**ADDENDUM TO THE BIDDING DOCUMENTS FOR:**

**Rehabilitation Renovation**

Captain James A. Lovell  
Federal Health Care Center  
3001 Green Bay Road  
North Chicago, IL 60064

Lovell FHCC Rehabilitation Renovation  
VA Project # 556-12-145  
BAE Project # 13-109

**LOVELL FHCC  
REHABILITATION**  
DETAIL #7/A-R-601  
RATED ACCORDION PARTITION  
SCALE: 1 1/2" = 1'-0"

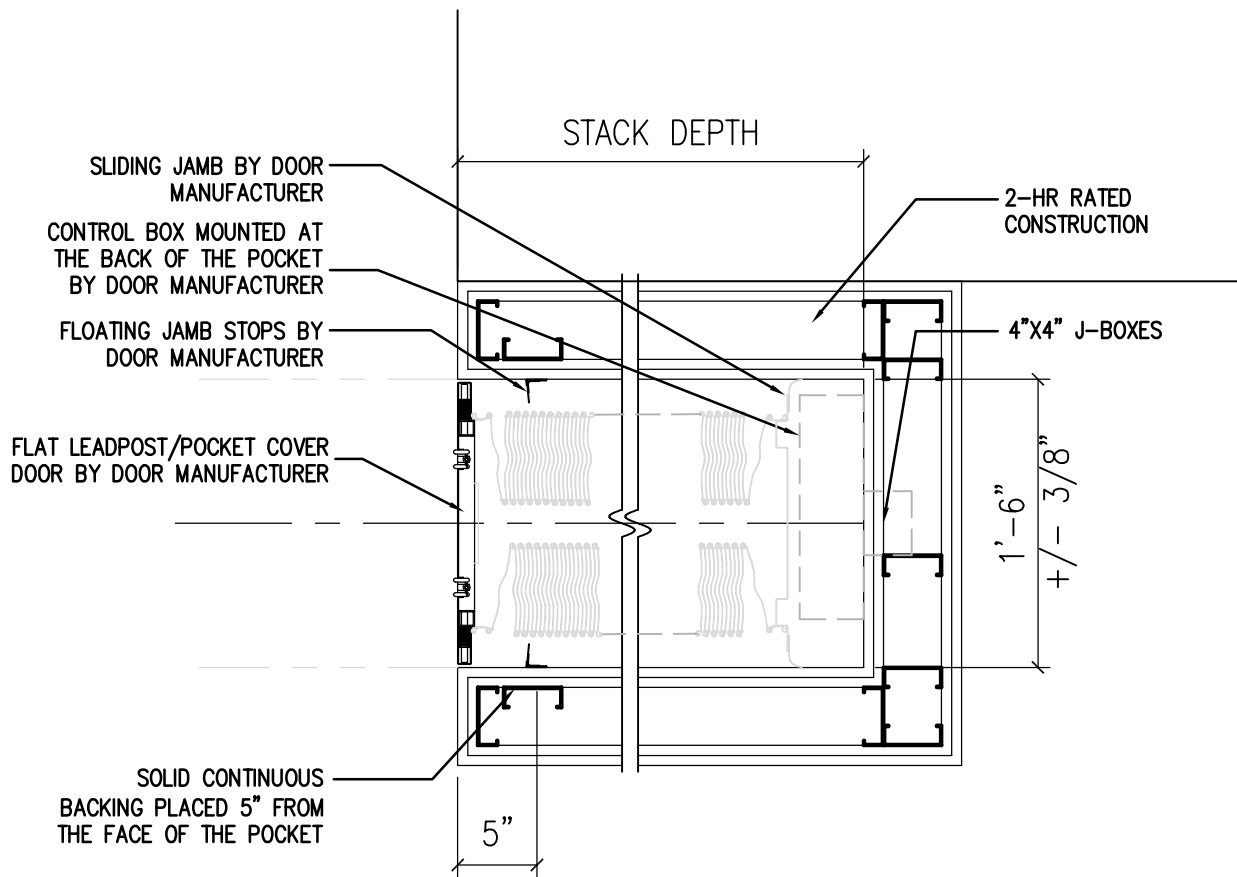
- 1.4 Specified rated accordion door has been modified to a Flat Lead Post Integrated Pocket door style. Replace Detail #7 with attached revision CS-01
- 1.5 Specified rated accordion door has been modified to a Flat Lead Post Integrated Pocket door style. Replace Detail #8 with attached revision CS-02
- 1.6 Modified accordion door detail to accommodate straight (non-curved) application. Replace Detail #9 with attached revision CS-03
- 1.7 Specified rated accordion door has been modified to a Flat Lead Post Integrated Pocket door style. Remove Door 161-D Pocket Cover Door and associated hardware from scope
